AMENDMENT NO. 0001 TO ADVERTISED RFP DACW31-03-R-0008
EFFECTIVE: APRIL 23, 2003

LUKE C. MOORE ACADEMY HIGH SCHOOL

SHEET: A-1.2

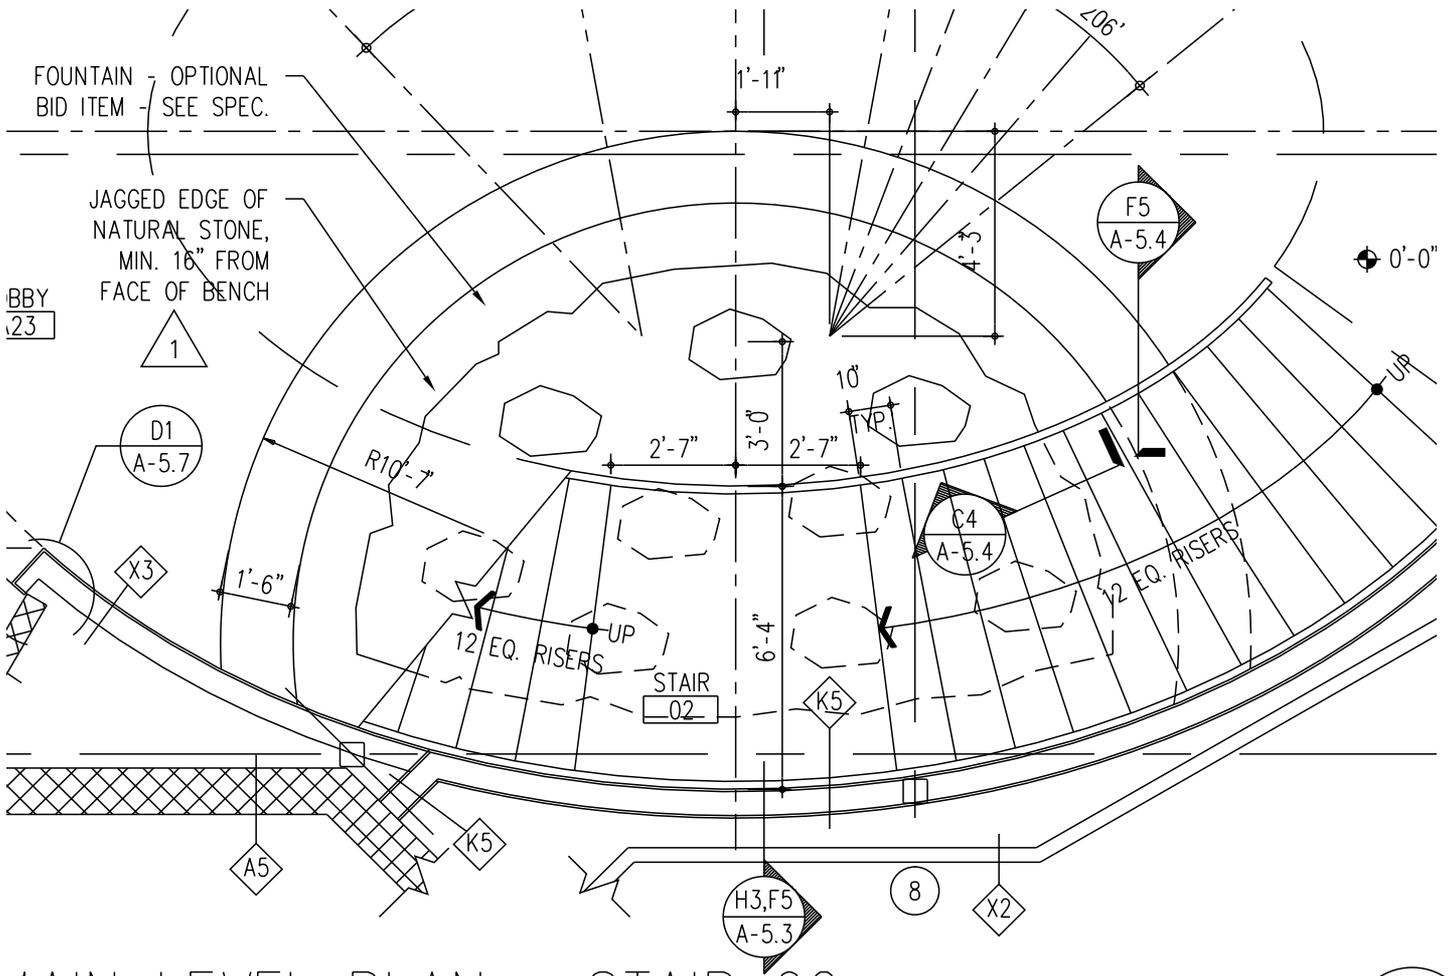
- 64) Sheet A-1.1: Revise notes referencing “ADDITIVE BID ITEM” to “OPTIONAL BID ITEM.”
- 65) Sheet A-1.2:
- a) Add new corridor doors B10a as shown on attached drawing SK-A-1 dated 4/17/03.

SHEET: A-5.3

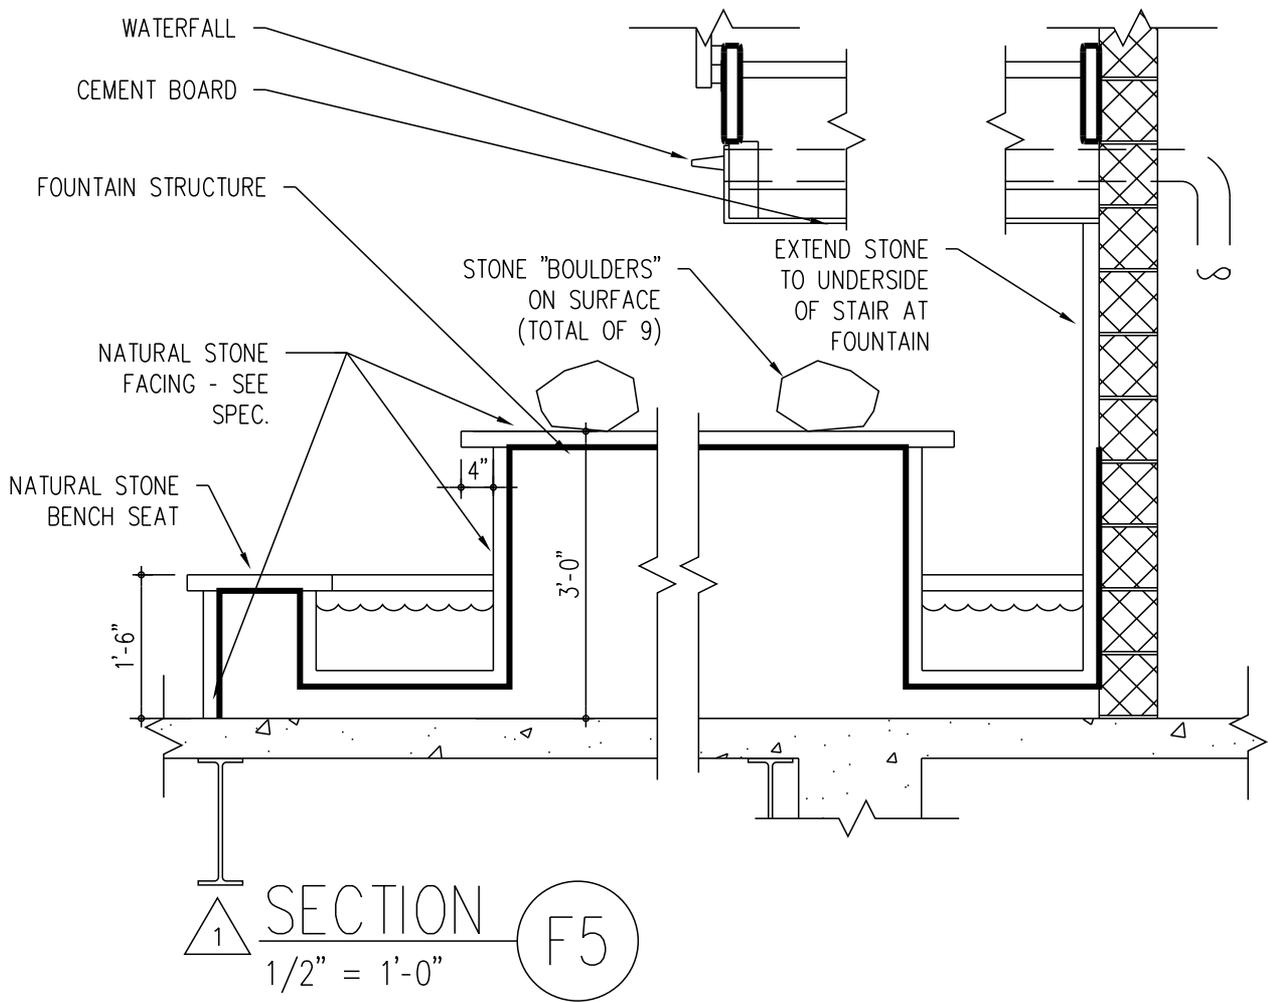
- a) Details E1 and H1 - Revise notes referencing “ADDITIVE BID ITEM” to “OPTIONAL BID ITEM.”
- b) Detail H1 – revise note at fountain as follows: “FOUNTAIN WITH NATURAL STONE FACING – OPTIONAL BID ITEM.”
- c) Detail E1 - Add notes, section references, and additional detail at fountain below stair as shown on attached drawing SK-A-3 dated 4/17/03.
- d) Add new detail F5 as shown on attached drawing SK-A-4 dated 4/17/03.

1
 1"=1'-0"
 DETAIL- STAIR TREAD (C4)

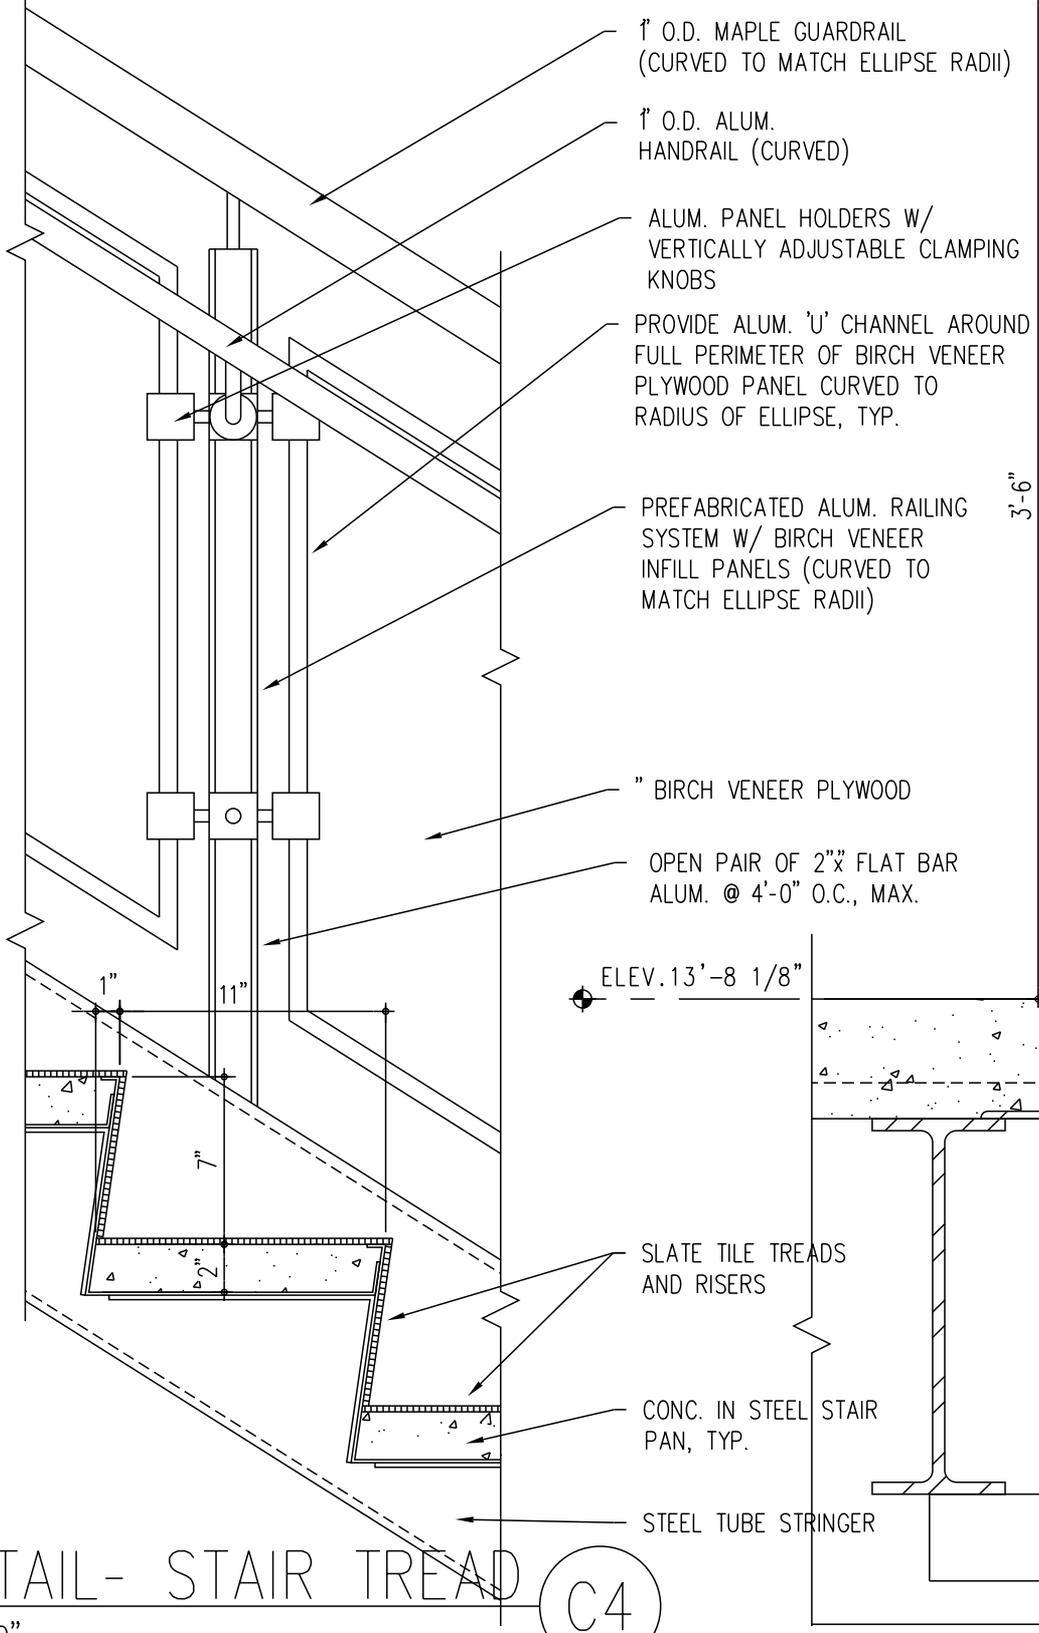
- a) Details D4 and F5 – Add the following note: “PROVIDE ALUM. ‘U’ CHANNEL AROUND FULL PERIMETER OF BIRCH VENEER PLYWOOD PANEL CURVED TO RADIUS OF ELLIPSE, TYP.”
- b) Add new tread detail C4 as shown on attached drawing SK-A-5 dated 4/17/03.

SHEET: A-5.7

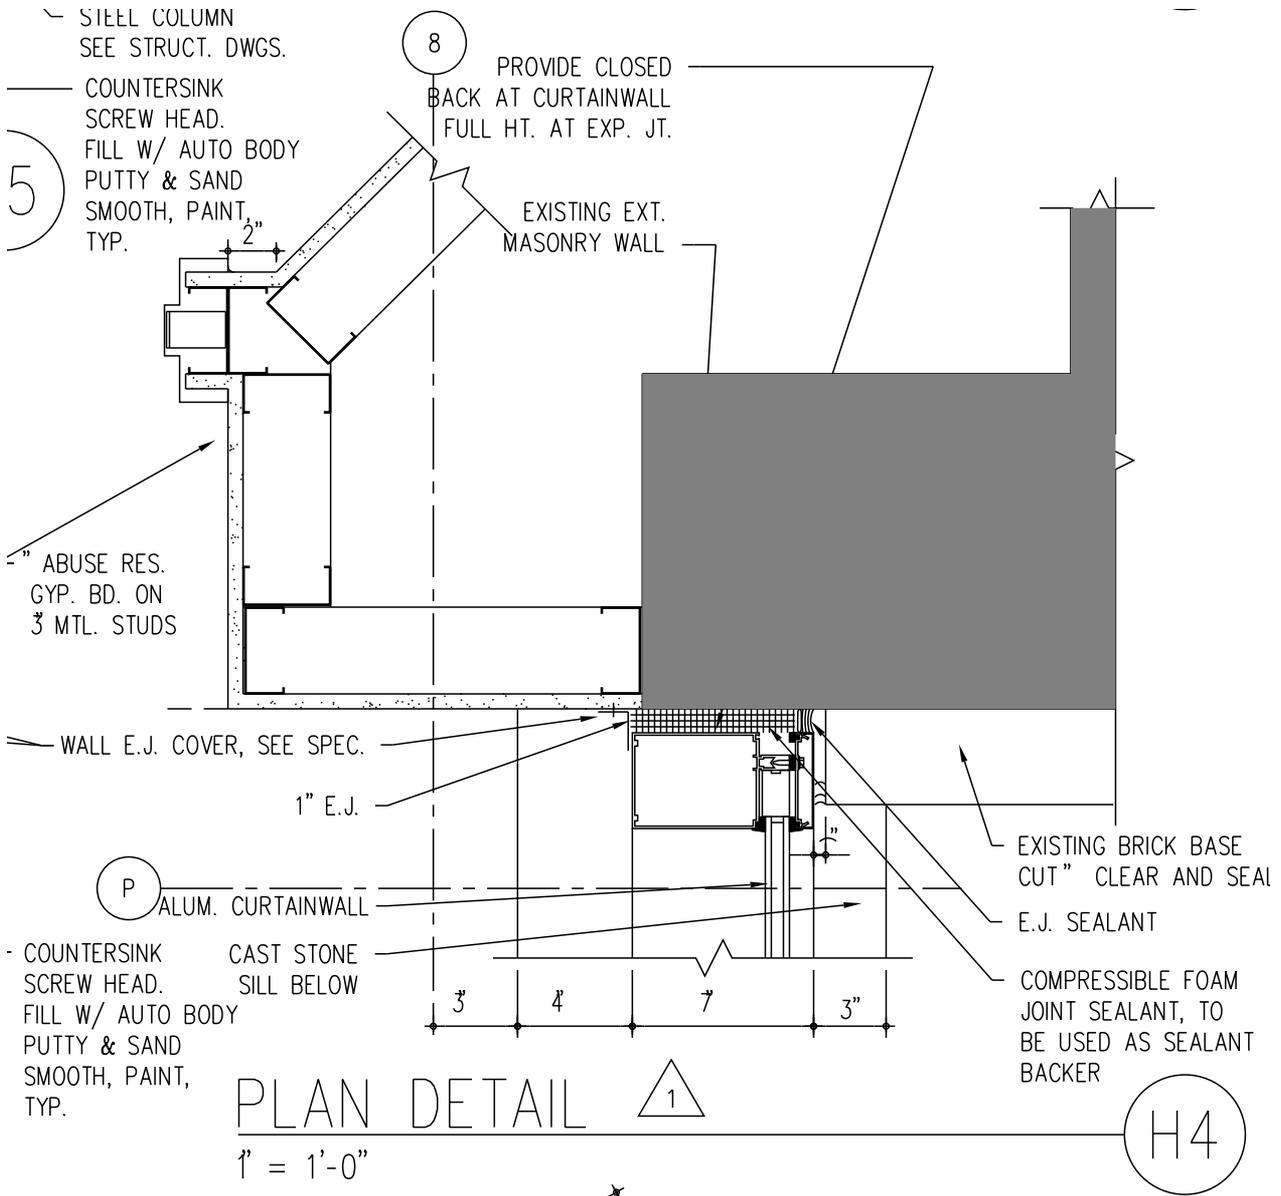
- a) Sections B1, B2, and B4 - Revise notes referencing “ADDITIVE BID ITEM” to “OPTIONAL BID ITEM.”
- b) Revise details H4, G4 and D4 as shown on attached drawings SK-A-6 through SK-A-8 dated 4/17/03.
